Access Compliance Report

Public Rights-of-Way

Intersection ID: 10037433	Main Street: SCOTLAND_HALL_CT	Cross Street: N/A	Location: SE
ADA ID: DCA330A7549A	Ramp Type: Perp	Initial Pass/Fail: Fail	Overall Compliance: No
Codes/Mitigation Info/Possible Solution		Field Measurements/Component Compliance	
Severity Score: 33.75

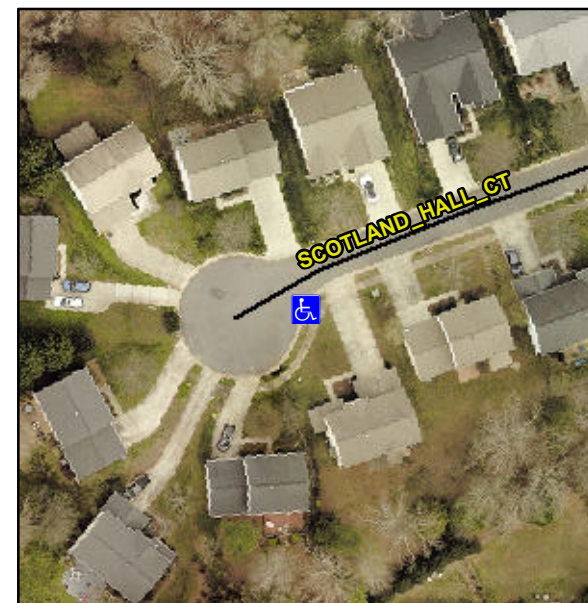
Not Found, R304.5.1, R304.2.2

Compliance	Description	Data	Compliance	Description	Data
N/A	Ramp Length (in)	46.5	No	Ramp Slope (%)	13.3
No	Ramp Width (in)	36.0	Yes	Ramp XSlope (%)	0.9
N/A	Flare Type LT	N/A	N/A	Flare Type RT	N/A
N/A	Flare Slope LT (%)	N/A	N/A	Flare Slope RT (%)	N/A
N/A	Flare Traversable LT?	N/A	N/A	Flare Traversable RT?	N/A
N/A	Landing Length (in)	N/A	N/A	DWS Provided?	N/A
N/A	Landing Width (in)	N/A	N/A	DWS Contrast?	N/A
N/A	Landing Slope (%)	N/A	N/A	DWS Length (in)	N/A
N/A	Landing X Slope (%)	N/A	N/A	DWS Full Width?	N/A
N/A	Landing Curb? (Y/N)	N/A	N/A	DWS Offset (in)	N/A
N/A	Shared Landing?	N/A			
N/A	Gutter Ponding?	N/A	N/A	Gutter Slope (%)	N/A
N/A	Gutter Lip Ht (in)	N/A	N/A	Gutter X Slope (%)	N/A
N/A	Painted X Walk1?	No	N/A	Painted X Walk2?	N/A
	X Walk 1 Direction	To N		X Walk 2 Direction	N/A
N/A	X Walk 1 Width (in)	N/A	N/A	X Walk 2 Width (in)	N/A
	X Walk 1 Slope (%)	3.4		X Walk 2 Slope (%)	N/A
	X Walk 1 X Slope (%)	1.7		X Walk 2 X Slope (%)	N/A

Remove & Replace Entire Ramp.
